**PROCUREMENT SERVICES
ADDENDUM**

Date of Notice:	1/22/2025
Solicitation No.:	IB-010-25
Title:	HSC Restroom Renovations
Addendum No.:	1

IB-010-25

Addendum 1

④ 55B - SECOND FLOOR RESTROOMS - FIRE PROTECTION - NEW WORK
3/16" = 1'-0"

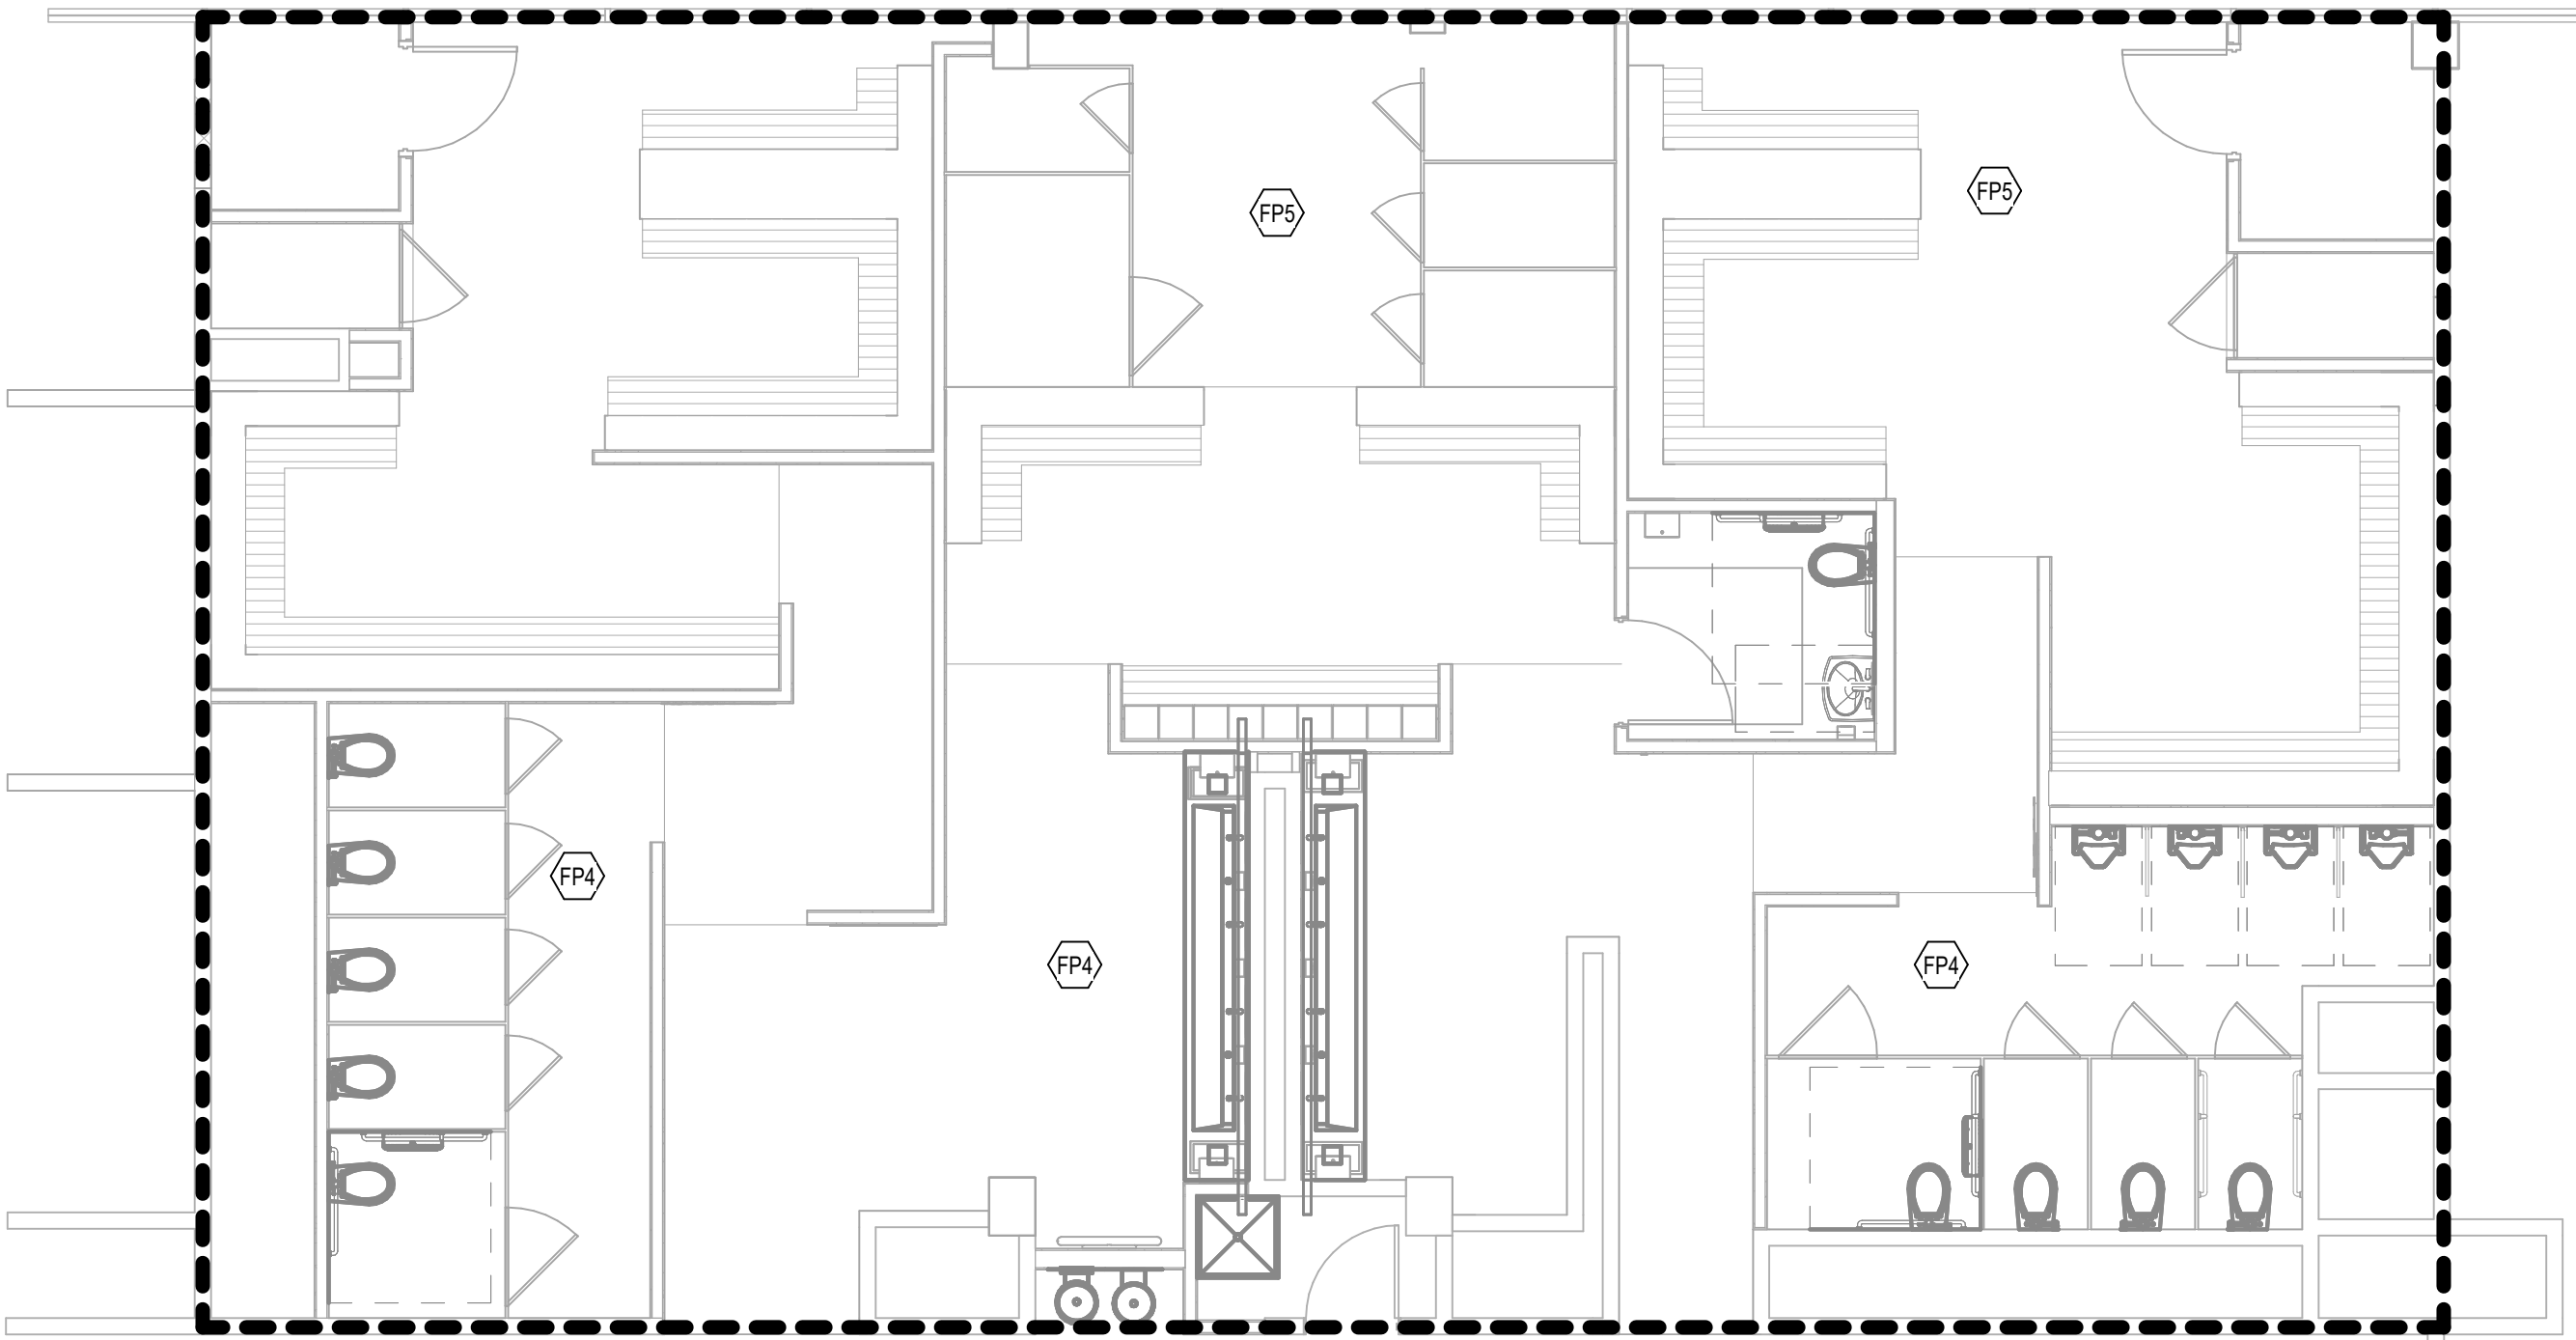
6. Is there any sprinkler scope for 55B building?

University Response: For Fire Protection scope within 55B, see **revised sheets 55BFP101** for clarification of scope.

55A-101

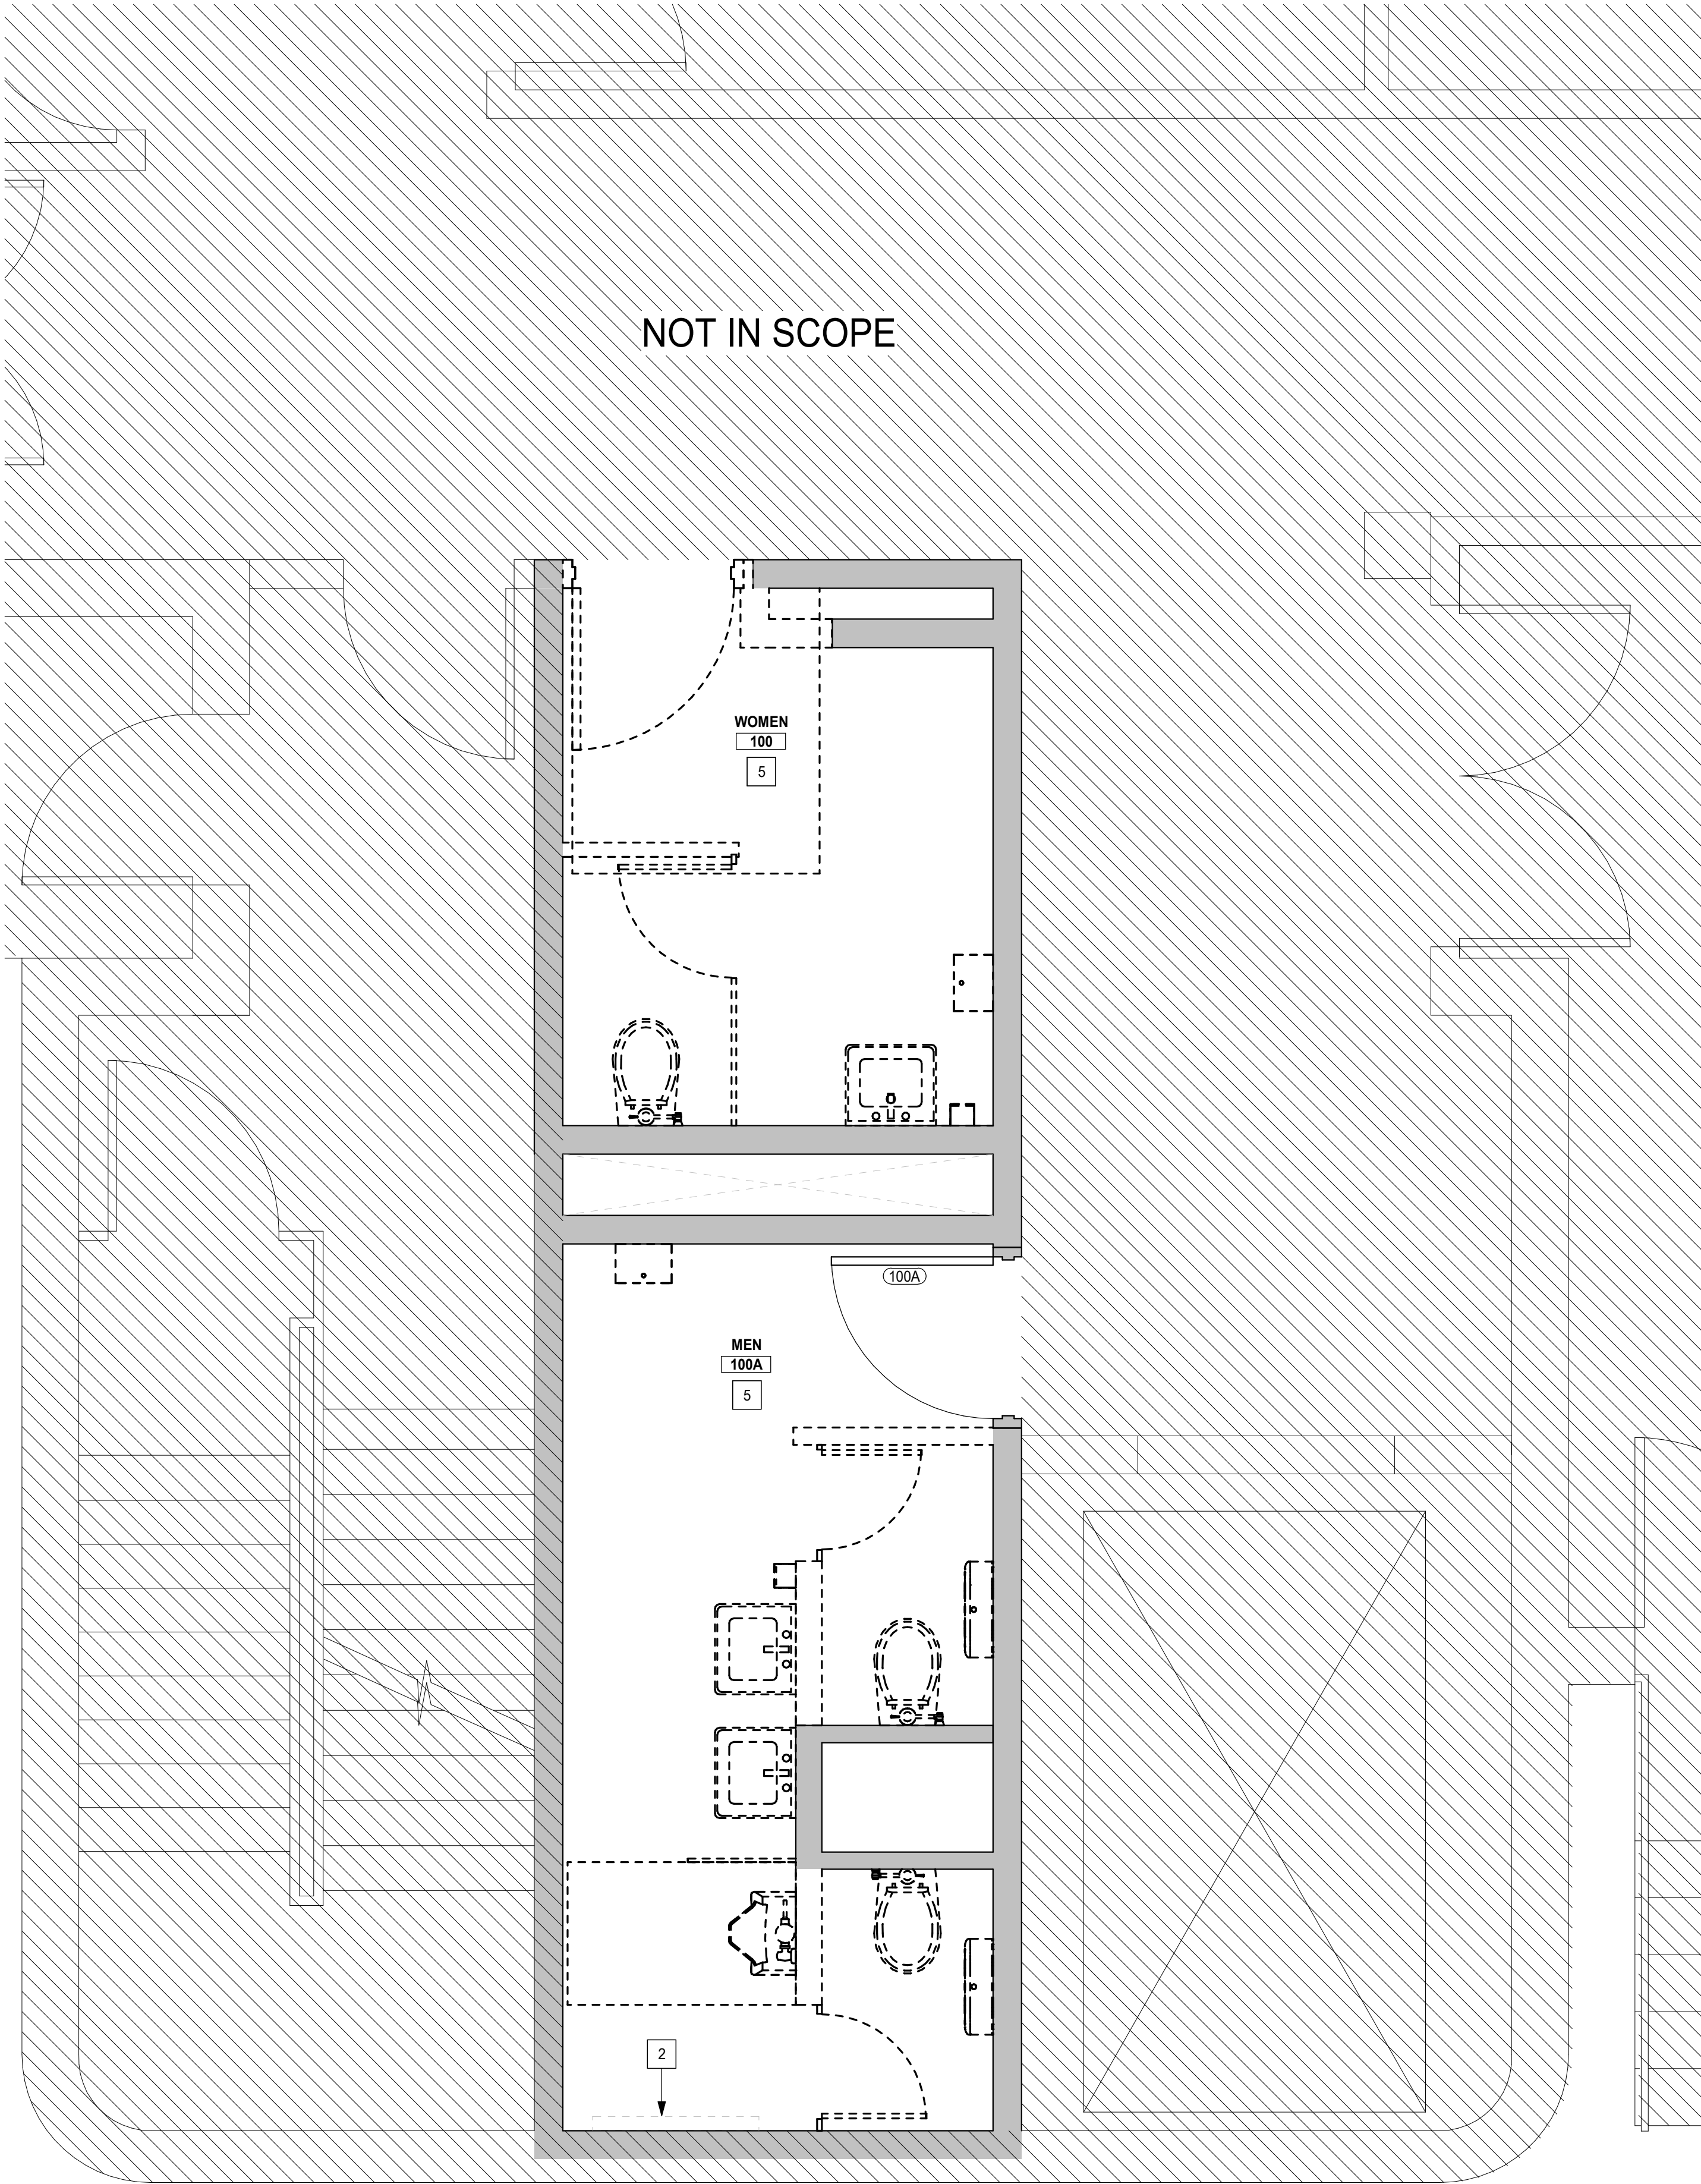
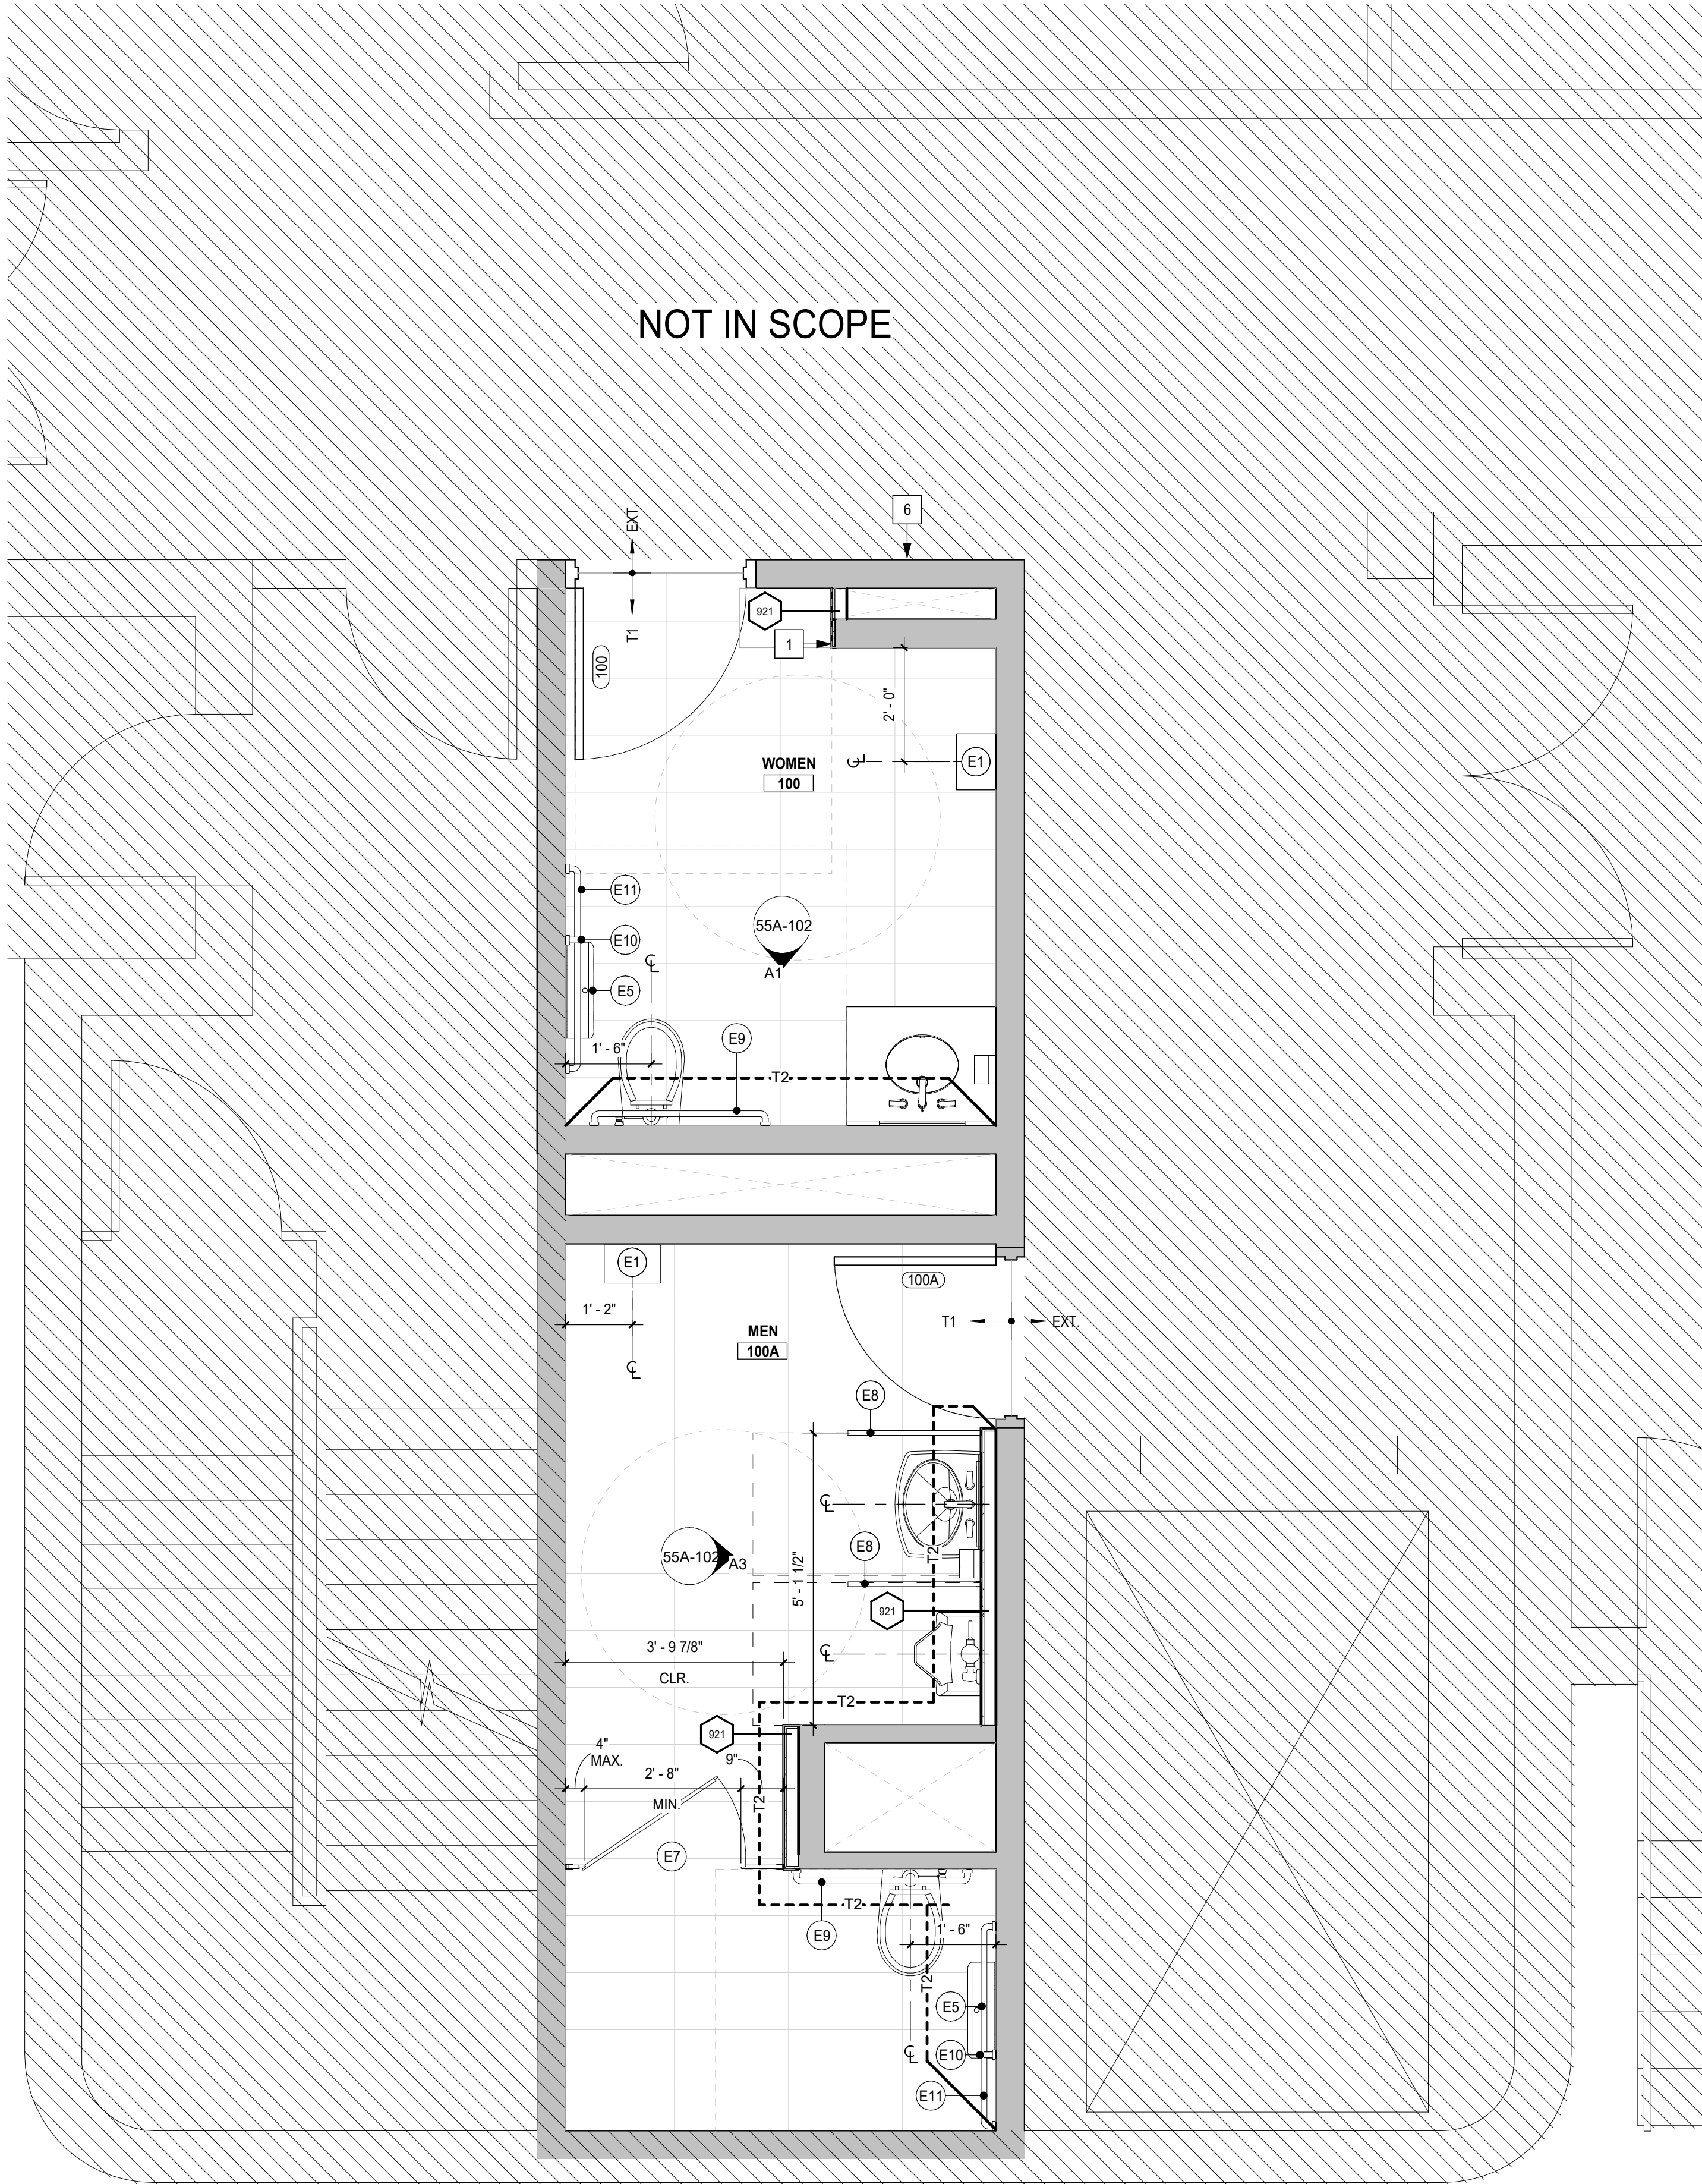
8. **Clarification Item 1:** Within the 55B 1st Floor scope, ceiling material has been updated. See **revised 55B-202** attached for clarification.
9. **Clarification Item 2:** Within the 55B 2nd Floor scope, flooring material is shown for scope clarity. Additionally, the door and mop sink location within Janitor Closet 299D have been updated. See **revised sheet 55B-103** attached for clarification.
10. **Clarification Item 3:** Within the 55B scope, Sheet Note 17 has been updated, see **revised sheets 55B-102 and 55B-103**.
11. **Clarification Item 4:** Within the 55A scope, Sheet Note 7 has been added, see **revised sheets 55A-101, 55A-102, and 55A-103**.
